Re: Docket No. 970643-EI

Staff Information Request  
Docket No. 970643-EI  
GULF POWER COMPANY  
GENERAL QUESTIONS  
AND COMMENTS  
April 9, 1998  
Item No. 1  
Page 1 of 1

Staff Information Request  
Docket No. 970643-EI  
**GULF POWER COMPANY**  
**PRODUCTION PLANT**

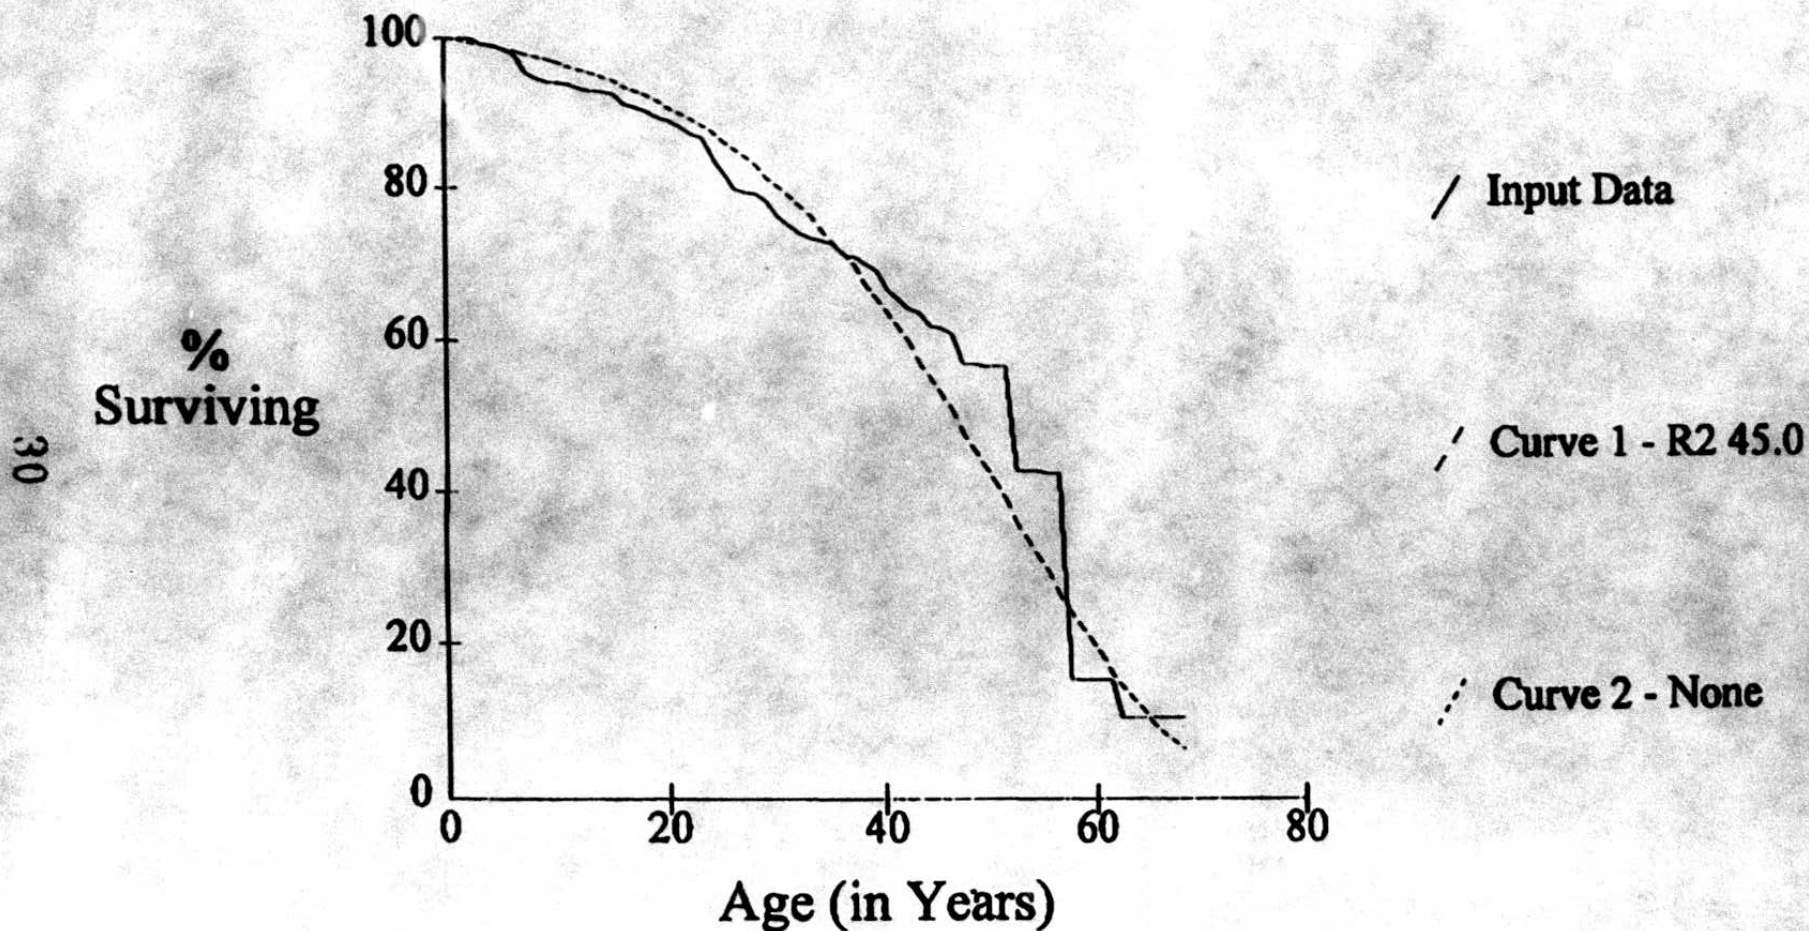
- f. Please elaborate on the Company's specific experience as it relates to the proposed increase in average service life.**
- g. What is the current average age for this investment, and what was the average age at the last study?**
- h. Are records maintained by vintage and location for each retirement unit in this account?**
- i. What information supports the selection of the 45-year service life, as compared to 40, 43, or 46 years for example?**
- j. Also, please provide the theoretical reserve percentage along with the calculation by which it was determined.**

- f. As previously stated in response to 6 (b), the growth in the account does not necessarily cause an increase in the average age of the account. The relative young age of new investment is dollar-weighted with the older age of all other surviving investment. Therefore, it is reasonable and logical for the average age to increase with the addition of new investment.

The life of Gulf's Transmission substation equipment should be increased based on the actuarial data supporting Gulf's depreciation rate study. Attached (attachment A) is the -Actuarial Graph- for Account 353 supporting Gulf's estimate of the R2-45 curve and life. With respect to other Florida utilities, the life of Gulf's transmission substation equipment is based on historical data that shows a longer life and should be depreciated accordingly.

Transmission substations, particularly step-up subs, are built to higher specifications than distribution subs to ensure transmission system reliability. These stations in the Southern system are built for larger capacity and do not typically undergo growth and changing customer needs as do Distribution substations. Other companies within the Southern system are also experiencing the longer lives for this equipment. Currently, Georgia Power Company and Mississippi Power Company are using 49 years and 45 years, respectively. It is reasonable to assume that Gulf's experience is more related to that of its sister companies since Southern maintains an integrated system.

Staff's premise that the life of Distribution substation should be reduced to create a contrast with Transmission substation equipment is not logical and is not supported by the historical data. Attached (attachment B) is the -Actuarial Graph- for account 362 which clearly supports Gulf's position that the curve and life for this account should be an R2-38. Also attached (attachment C & D) are two exhibits presenting the percent surviving of original placements for both accounts 362 and 353. For account 362, there is approximately 50% or less surviving for investments which have attained an age equal to its average service life of 38 to 40 years. This would be expected for an R2-38 curve and life. The age at which there is consistently 50% survivors or less for transmission substation equipment is much older.
